**SAFETY EVALUATION REPORT  
REVIEW OF APPLICATION TO AMEND LICENSE CONDITION 11.3(C), LICENSE SUA-1601,  
STRATA ENERGY, INC. ROSS IN SITU RECOVERY FACILITY, CROOK COUNTY, WY**

**DATE:** January, 2018

**LICENSEE:** Strata Energy, Inc.

**TECHNICAL REVIEWER:** John L. Saxton

Figure 1. Well Yields of 0.5 GPM as a Function of Available Water Column, Transmissivity and Storativity

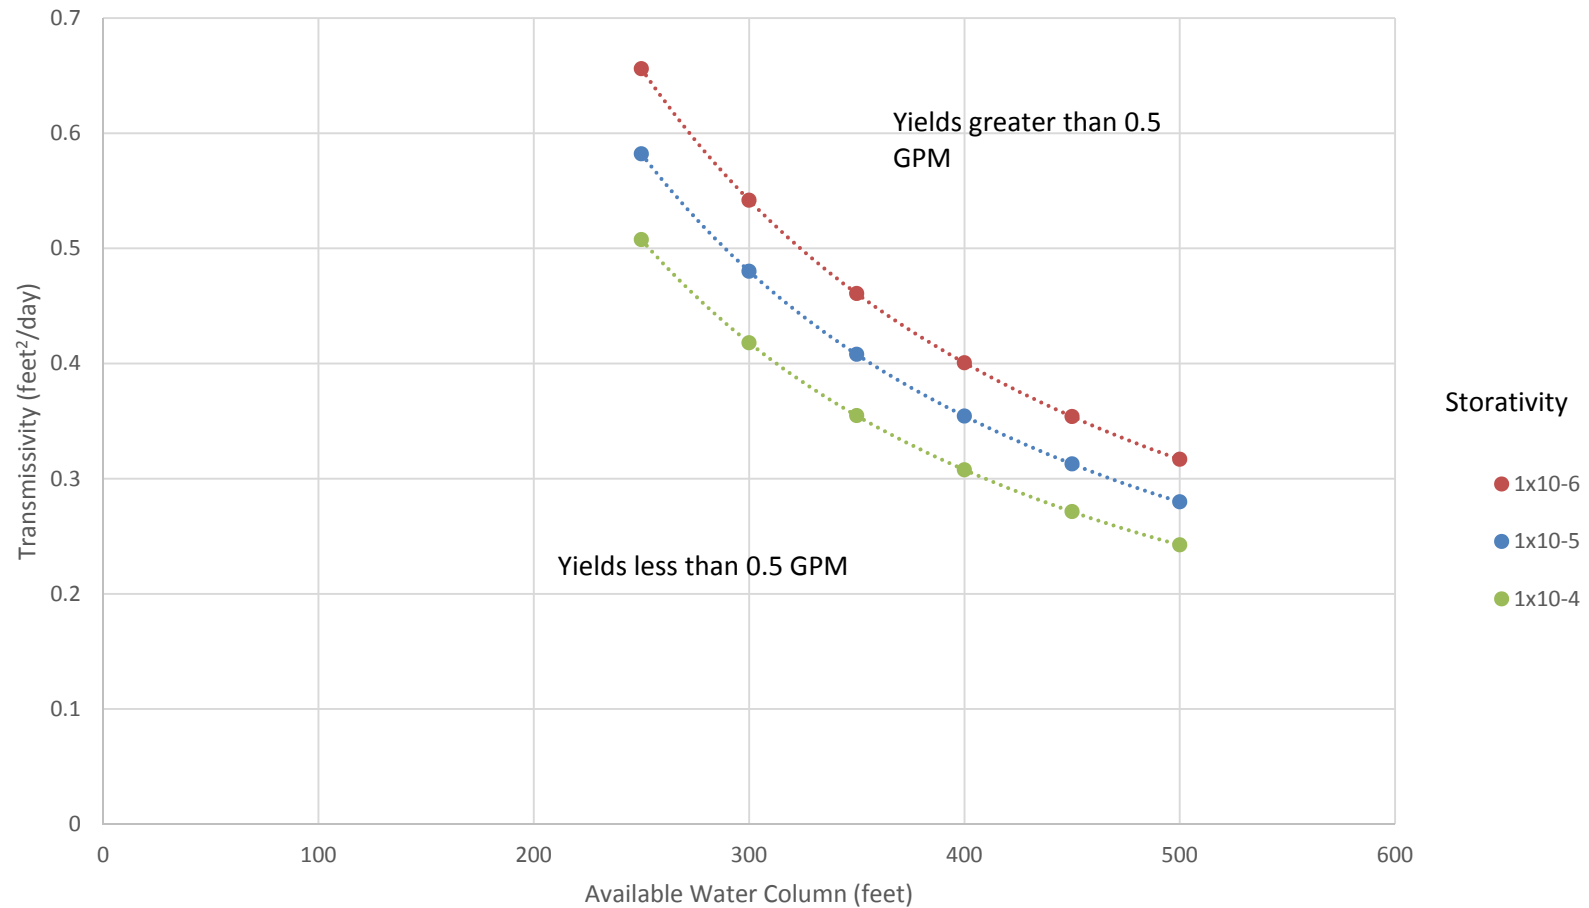
The NRC staff finds Strata's proposed criterion 5 acceptable because it is based on established State of Wyoming criteria. Furthermore, staff find the procedures used by Strata acceptable (with one caveat listed below) because they quantify a sustainable yield for a specific well based on (1) estimates of the hydraulic properties for the aquifer in the vicinity of the well using established slug testing methodology, (2) an appropriate period for sustainable pumping, (3) utilizing actual water column in the pumping well available for cumulative drawdown, and (4) established models for non-equilibrium radial flow to a well. The assumed parameters for Strata's analysis include storativity of the aquifer ( $1 \times 10^{-5}$ ), estimated available water column with a factor of safety (20 feet above the pump intake which is 30 feet above the top of the screened horizon) and the pumping duration (365 days). The measured parameters for Strata's analysis include radius of the well screen (0.4375 feet), radius of the well casing (0.1875 feet), aquifer thickness (13 to 25 feet), available water column (static water elevation minus the maximum safe drawdown elevation) (205.8 to 493.9 feet) (Strata, 2017c). The calculated parameters for Strata's analysis include transmissivity of the aquifer and well yield. The NRC Staff finds that the assumed and measured parameters are appropriate and confirmed that Strata's calculations for the well yield are correct using Strata's assumed, measured and calculated parameters (Table 1).

Figure 2. Examples of Curve Fitting to Strata's Data and Estimation of Time to 0.25 Recovery

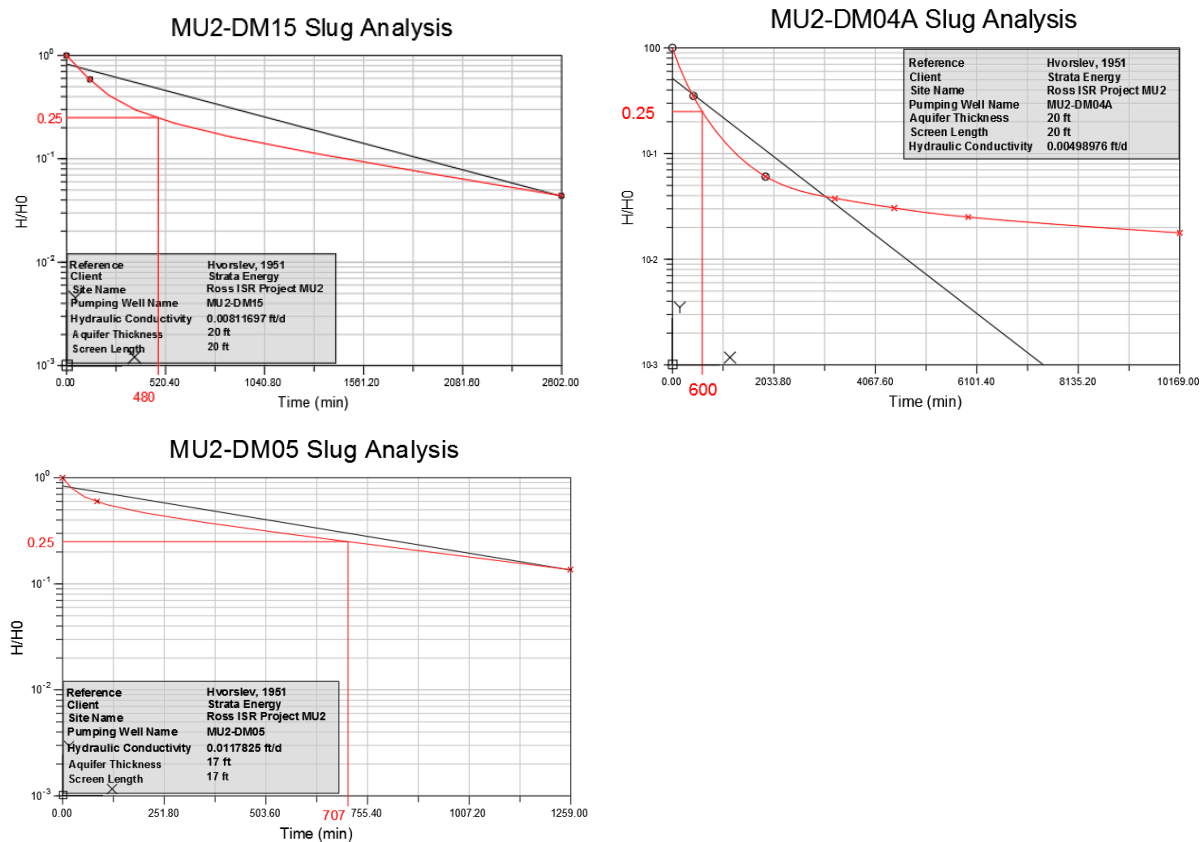
To establish whether Strata's proposal to eliminate any wells from monitoring was based on a flawed analysis, the NRC staff verified Strata's calculations by using the Cooper and Papadopulos methods to establish a transmissivity. The method typically consists of fitting the observed data to a model type curve and then establish a match point between the observed time and dimensionless time for the model curve (Dawson and Istok, 1991; Fetter, 1980). Because of the limited data, the NRC staff used a variant of the method by obtaining a match point for a selected normalized head. In this case, the NRC staff used a normalized head that was 25 percent of the initial head. To establish the normalized 25 percent head, curves were fitted to the data using Strata's graphs from the mine unit reports (for examples, see Figure 2).

In several cases, the limited data introduced an unacceptable degree of uncertainty in this analysis. If staff determined that Strata's data were insufficient for any analysis or the uncertainty in the curve assigned by staff yielded ambiguous results, then that well was eliminated from staff's verification process and, by default, included in the monitoring program.

The NRC staff determined that the data for wells MU2-DM01, MU2-DM05 and MU2-DM15 was insufficient or had sufficient uncertainty that the verification was deemed unnecessary and the wells were included in any proposed monitoring program. For the remainder of wells, the NRC staff estimated the time to the 25 percent normalized head varied between 0.2 and 13.7 days (Table 2).

Figure 3 Slug Test Model Curves for the Cooper and Papodopulos Model

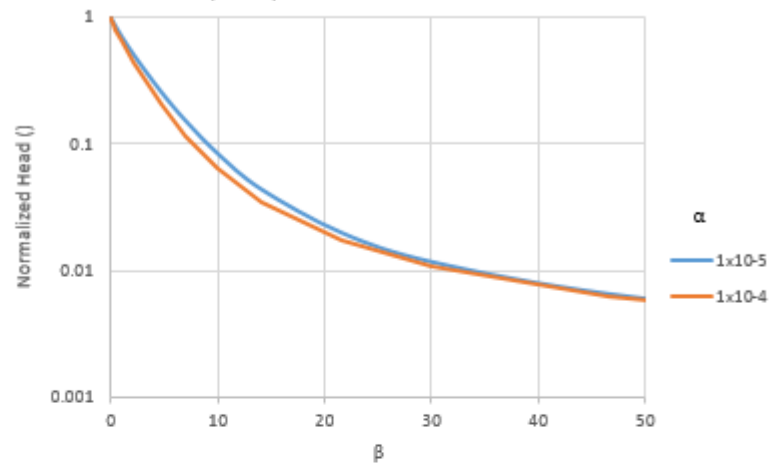
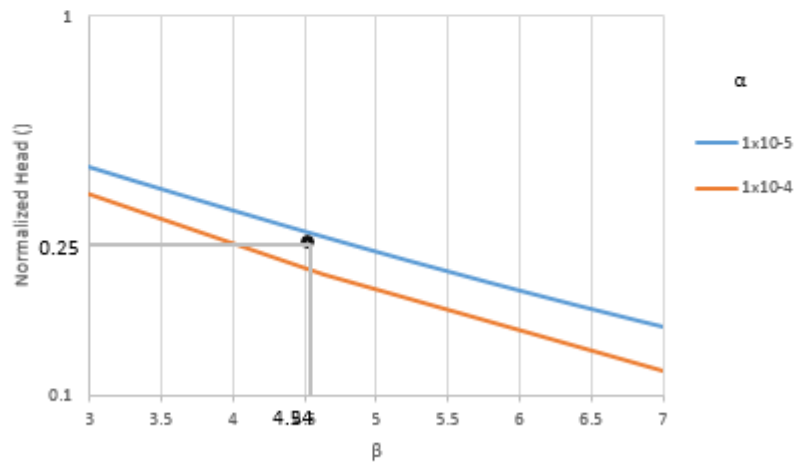
The model curves for  $\alpha^*$  values of  $1 \times 10^{-5}$  and  $1 \times 10^{-4}$  are shown on Figure 3a. Interpolation to the calculated value of  $5.44 \times 10^{-5}$  yields a  $\beta^*$  value of 4.54 (Figure 3b). Using this value for  $\beta^*$ , staff calculated the transmissivity of the aquifer at a well using the time to the normalized head of 0.25. An example calculation for well MU2-DM02 (where  $t^*$  is 0.52 days) is as follows:

$$\begin{aligned}T &= \beta^* r_c^2 / t^* \left( \frac{\text{sq ft}}{d} \right) \\ T &= 4.54 \times 0.1875^2 / 0.52 \left( \frac{\text{sq ft}}{d} \right)\end{aligned}$$

$$T = 0.31 \left( \frac{sq\ ft}{d} \right)$$

Figure 4. Mine Unit 1 and 2 Wells exceeding the Yield Criterion

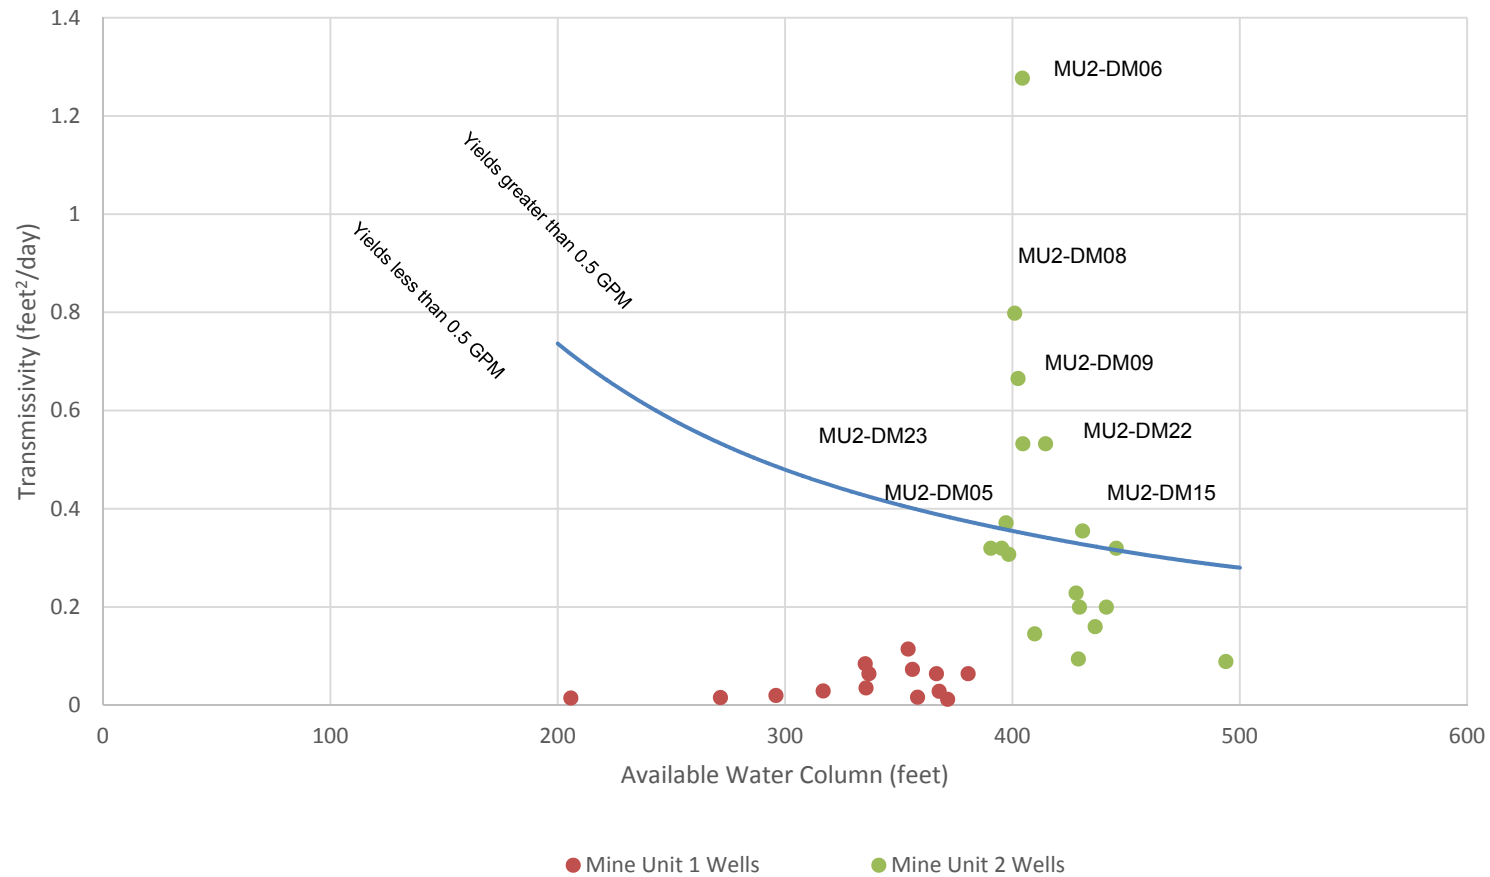
The calculated transmissivities through the verification process varied from 0.01 to 1.28 square feet per day (Table 2). Using the estimate of transmissivity developed through the verification process, a safe yield was determined for each well using the method described above (Table 2). The NRC staff's estimate of the transmissivity during the verification process was consistent with Strata's calculations (within 0.05 square feet per day) for all wells in Mine Unit 1 and wells MU2-DM02, MU2-DM11, MU2-DM14, MU2-DM16 and MU2-DM19. For wells MU2-DM04a, MU2-DM12a, MU2-DM17, MU2-DM18, MU2-DM20 and MU2-DM21, staff's verification transmissivity differed from Strata's calculation (greater than 0.05 square feet per day) but did not result in a predicted well yield greater than 0.5 gpm. For those wells, staff finds that that Strata's conclusions are valid (Figure 4). For wells MU2-DM-06, MU2-DM-08, MU2-DM-09, MU2-DM-22 and MU2-DM-23, staff's verification transmissivity resulted in a predicted well yield greater than 0.5 gpm and thus did not verify Strata's calculations.

Therefore, the NRC staff finds that all DM unit wells in Mine Unit 1, and the DM unit wells in Mine Unit 2 except wells MU2-DM01, MU2-DM-05, MU2-DM-06, MU2-DM-08, MU2-DM-09, MU2-DM15, MU2-DM-22 and MU2-DM-23, have a predicted yield less than WDEQ/LQD criterion of 0.5 gpm and recommends those wells be removed from the monitoring program as requested by Strata. Staff finds that predicted well yields for wells MU2-DM01, MU2-DM-05, MU2-DM-06, MU2-DM-08, MU2-DM-09, MU2-DM15, MU2-DM-22 and MU2-DM-23 cannot be verified and thus continued monitoring is required (i.e., Strata's request is denied for these wells). Strata may elect to re-perform slug tests at the wells that yield insufficient data and resubmit a request for staff to evaluate the new data in the future.

- Mine Unit 1: Monitoring at all wells is discontinued.
- Mine Unit 2: Monitoring is required at wells MU2-DM01, MU2-DM05, MU2-DM06, MU2-DM08, MU2-DM09, MU2-DM15, MU2-DM22 and MU2-DM23
